### PLAN CHANGE REQUEST

DATE: 09/11/24 PERMIT NO./REF NO: PRCCP20240215

1. PROJECT: PSE - OTC ADDRESS: 325 Todd Road NW

9. APPROVED CIVIL PLAN SHEET NUMBERS AFFECTED: C2.2A

CONCRETE SADDLE MANHOLE

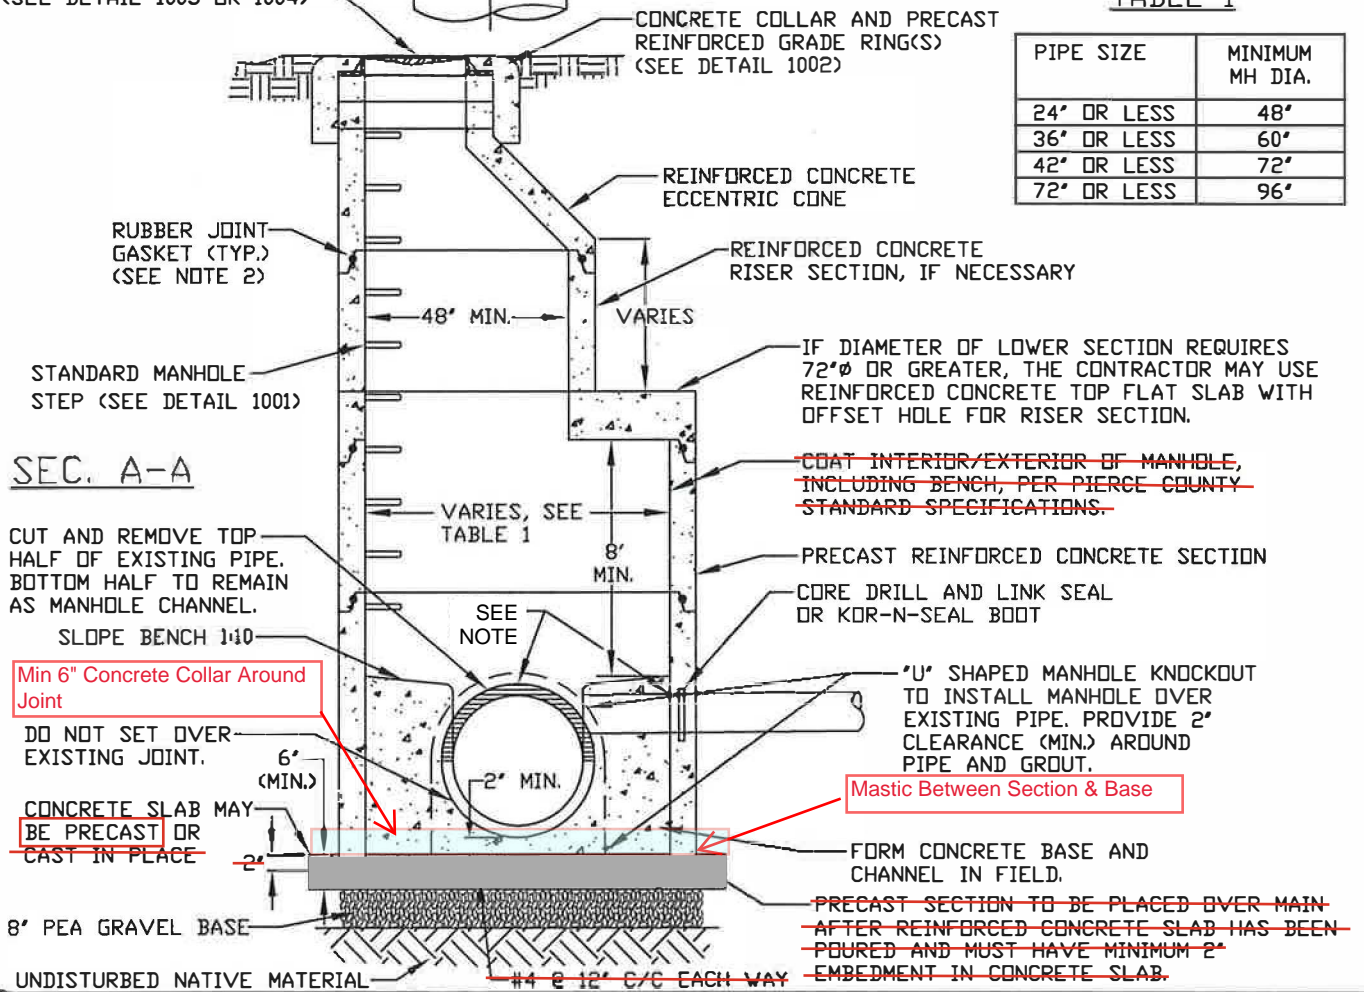
This is to clarify that a saddle manhole will be used at SSMH #1 on sheet C2.2A. The saddle manhole detail from Pierce County would be used as requested, the detail is attached for reference. The detail is modified to indicate 0.1' drop between inverts is required (rather than matching crowns). In addition, the interior/exterior coating is omitted and the bottom slab is noted as precast w/ pour concrete collar.

NOTE: PIERCE COUNTY REQUIRES 0.1' MIN. DROP BETWEEN INVERTS

~~COAT INTERIOR/EXTERIOR OF MANHOLE, INCLUDING BENCH, PER PIERCE COUNTY STANDARD SPECIFICATIONS.~~

~~PRECAST SECTION TO BE PLACED OVER MAIN AFTER REINFORCED CONCRETE SLAB HAS BEEN POURED AND MUST HAVE MINIMUM 2" EMBEDMENT IN CONCRETE SLAB.~~

This last email is to the city's satisfaction. We agree with the installation technique. The PCR needs to be updated with these corrections. I tried to just replace the detail page in Bluebeam but it wont take editing because of the signatures. I will work on it tomorrow. We want the PCR to have this info.

- Use a precast base which will be poured with rebar and sent to the Project.
- Set saddle manhole on top of precast base with mastic
- Pour a 6"-1' concrete collar around seam of precast base and saddle section
- Pour channel inside manhole.
- \*if required, we can install dowels/rebar inside the manhole from the saddle section into the base and pour the channel around the rebar to connect the section with the base.

I removed the #4 rebar note on the detail I sent because I thought it was referring to a cast in place installation and not the precast option. Please let me know if you have any questions.
